Re: Cherokee Nation WW Hastings Replacement Hospital - Addendum 02 Narrative

Following is a list of revisions included in Addendum 02.

PROJECT PHASE:
BID PACKAGE 02
(SITE DEMOLITION AND UTILITIES)

SHEET TITLE:
C7-213

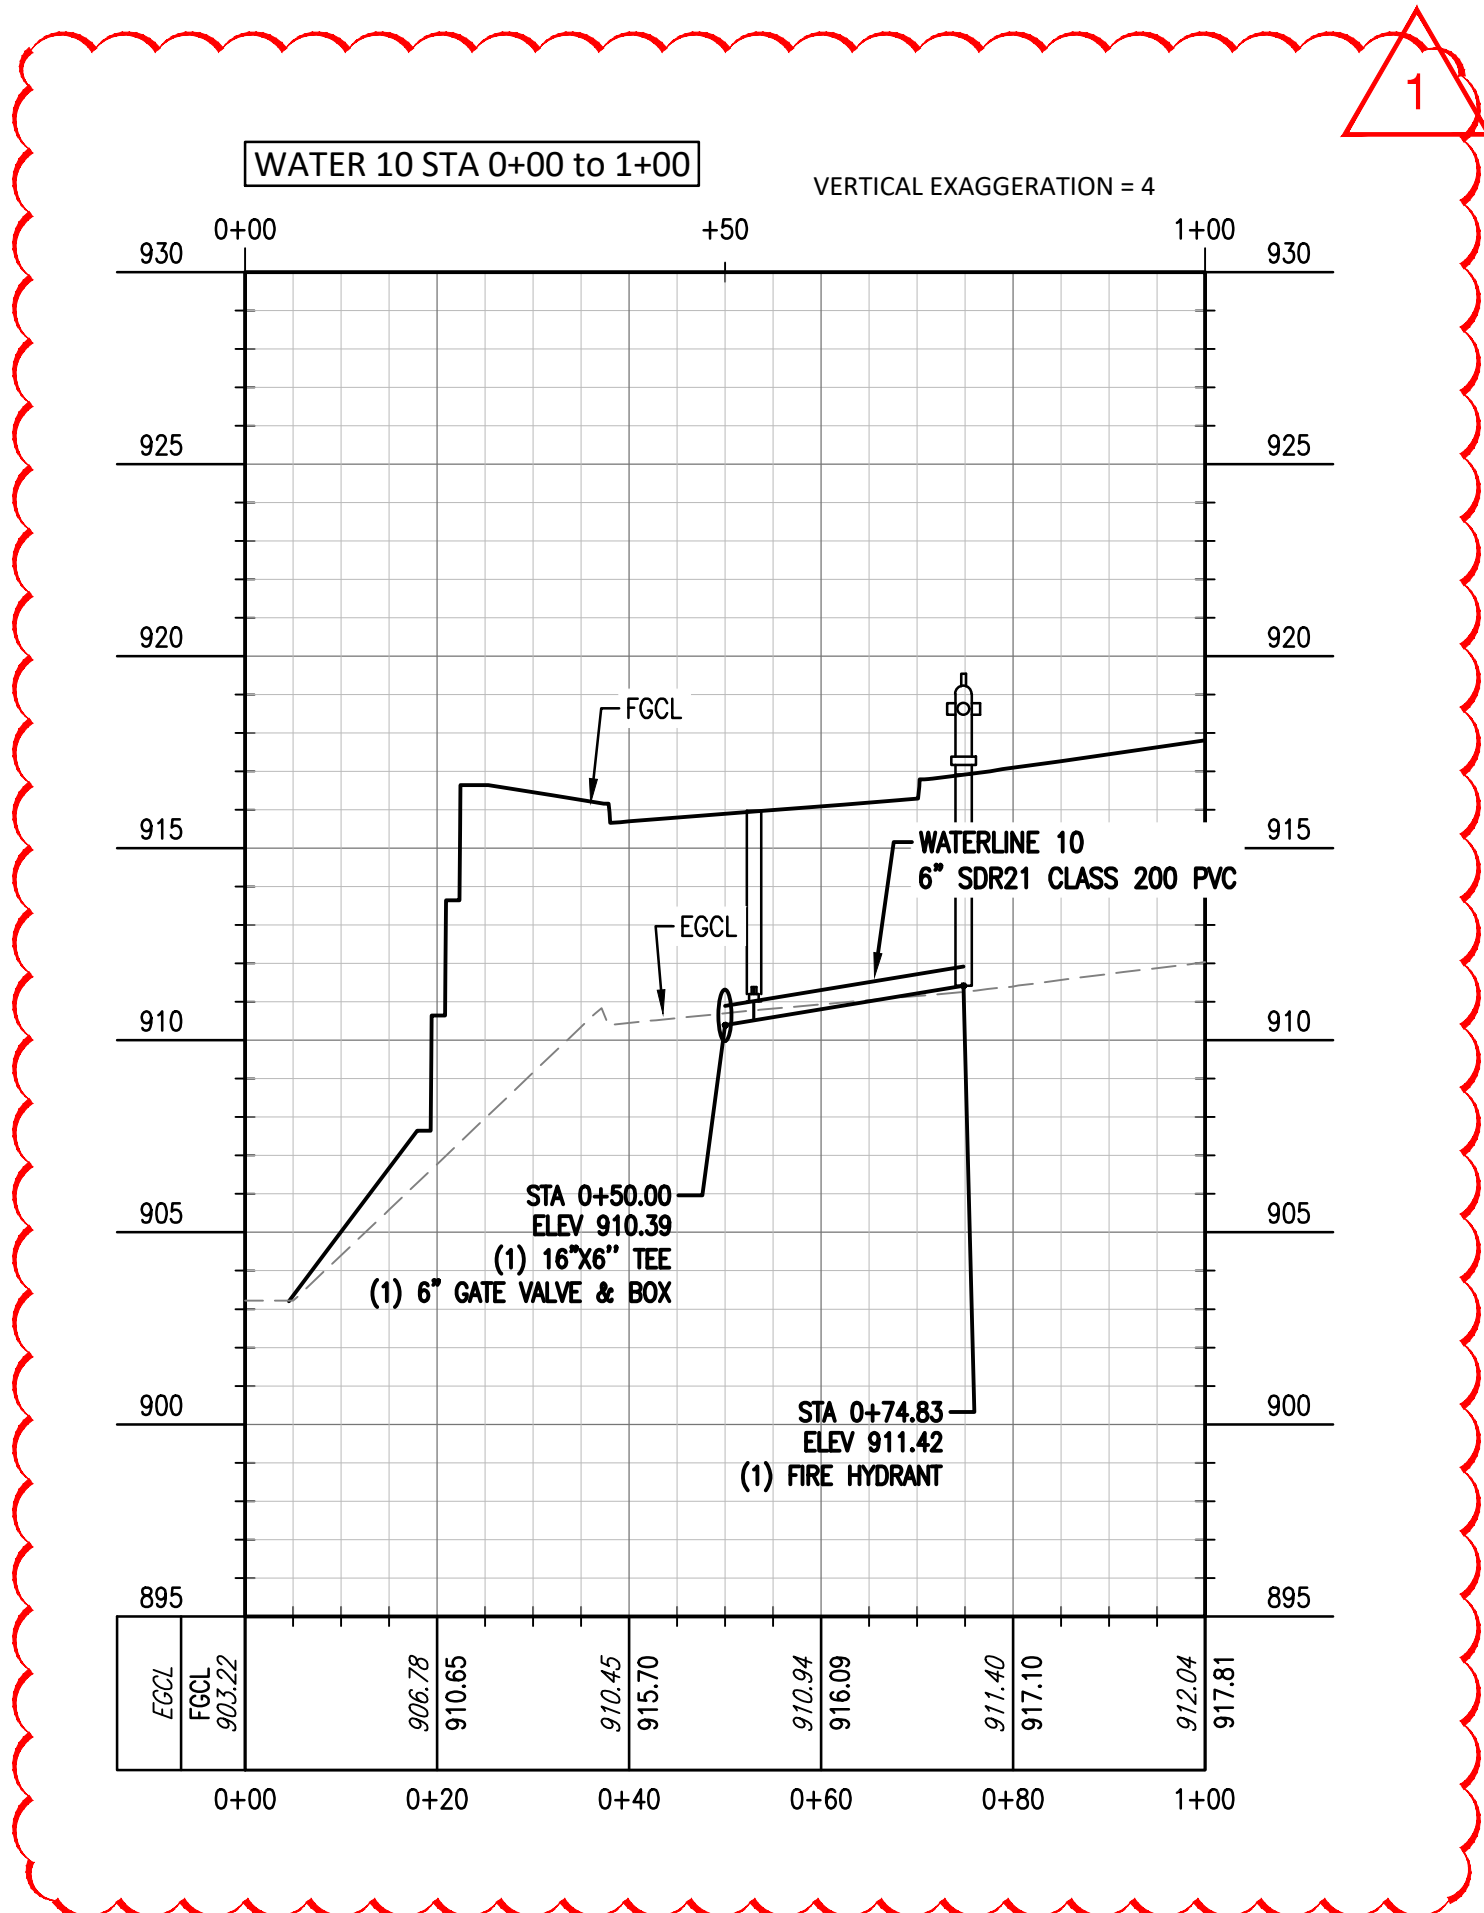
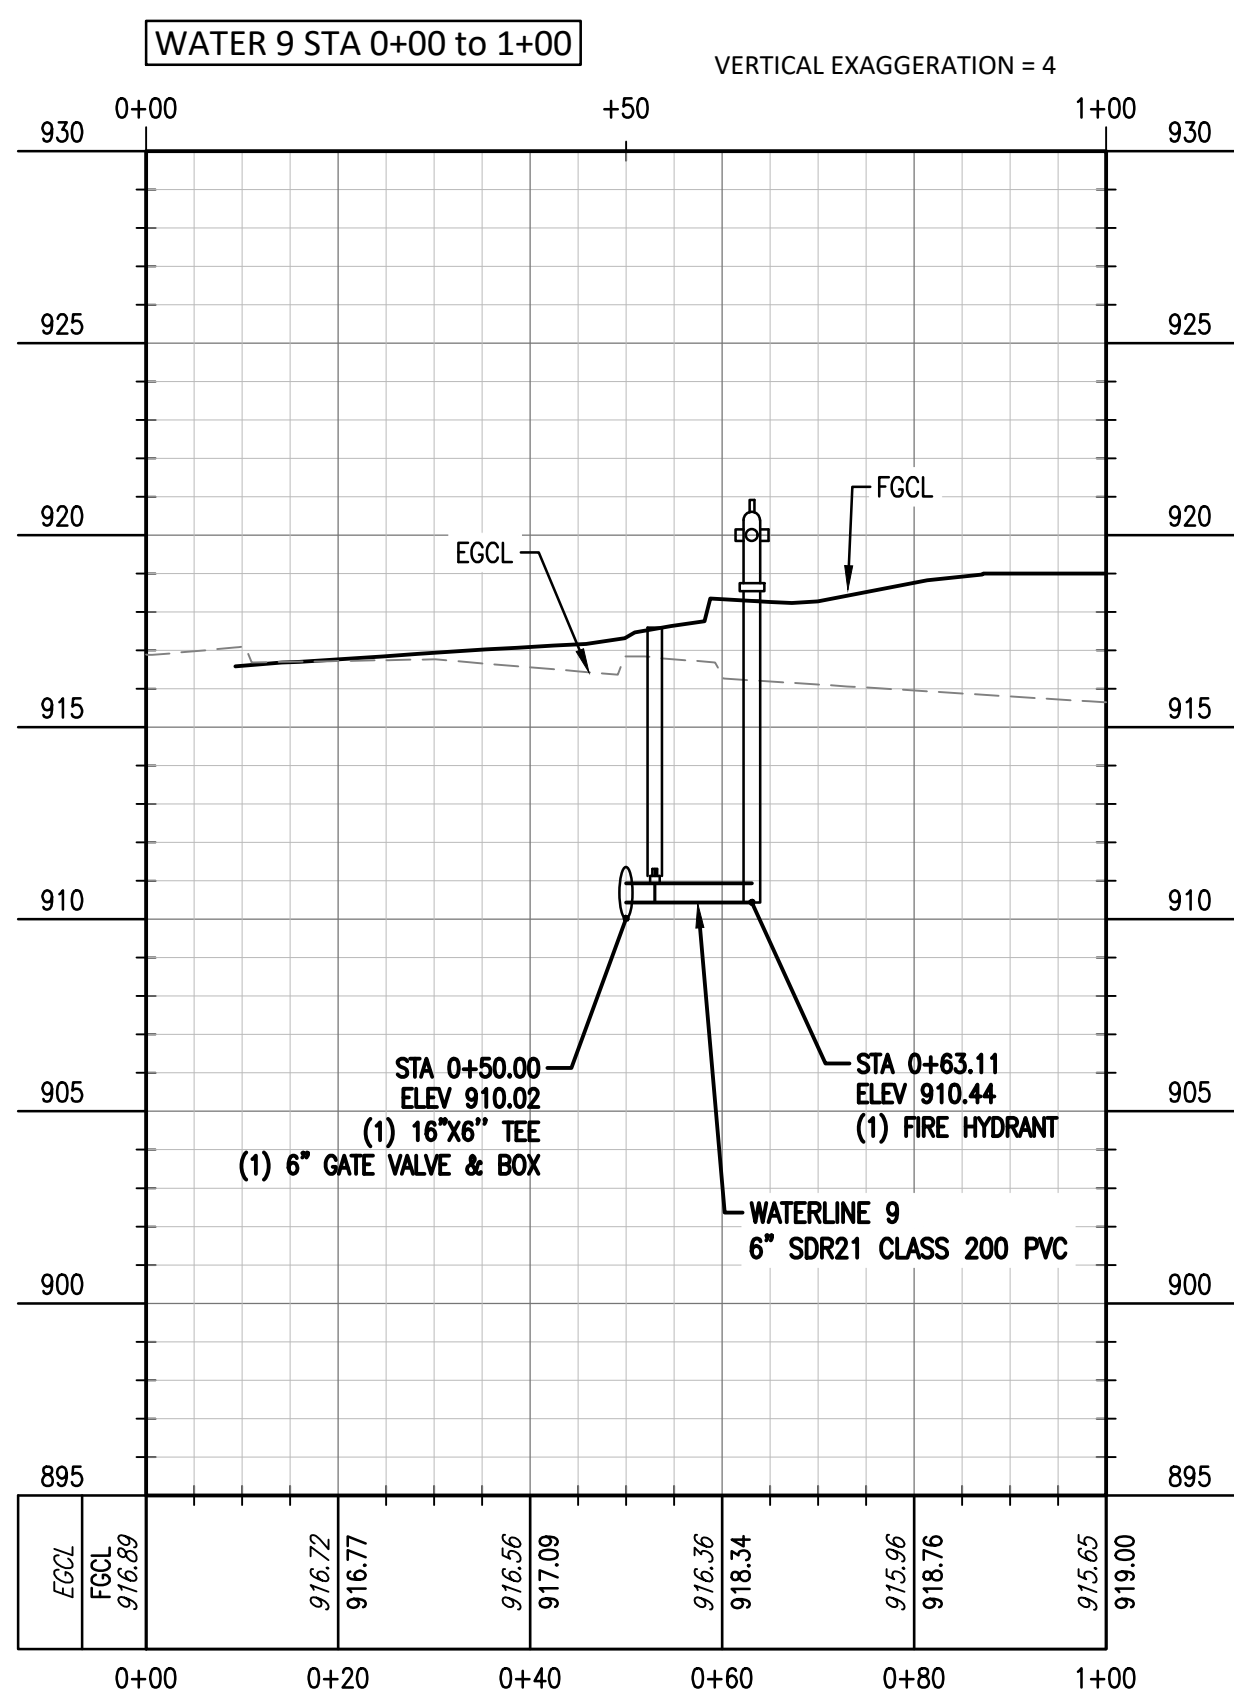
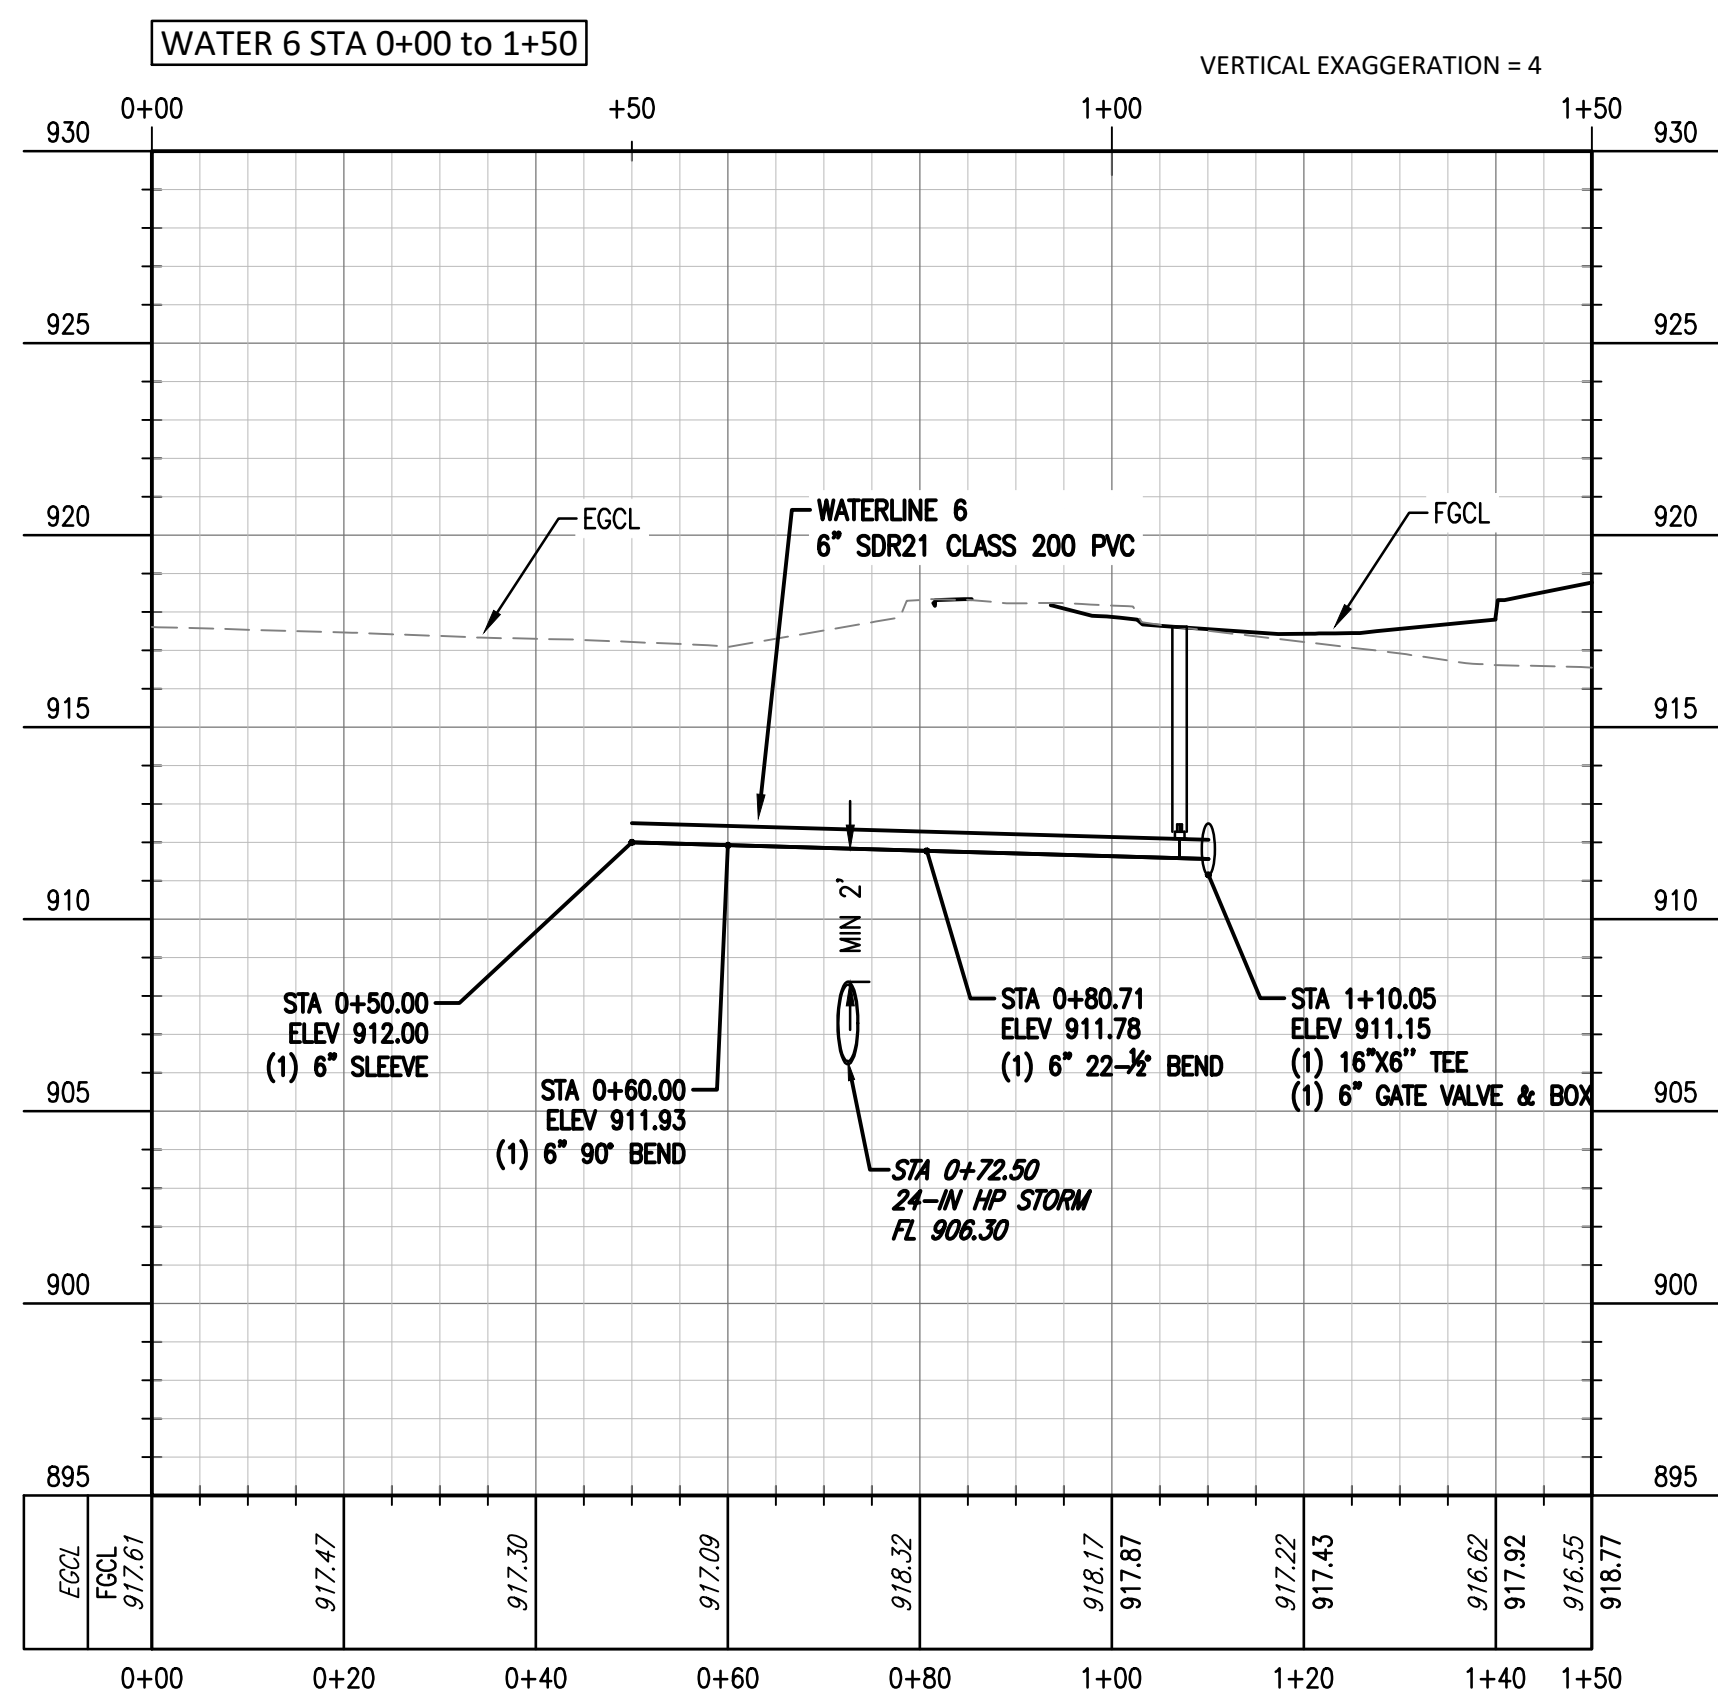
- C7-212 - Added the graphical presentation of the gate valve and fire hydrant to the profile view.
- C7-213 - Added call-outs to the materials in the plan view of Water 8.
Revised the profile view of Water 8 to match the plan.
Added labels to the plan view of Water 13.
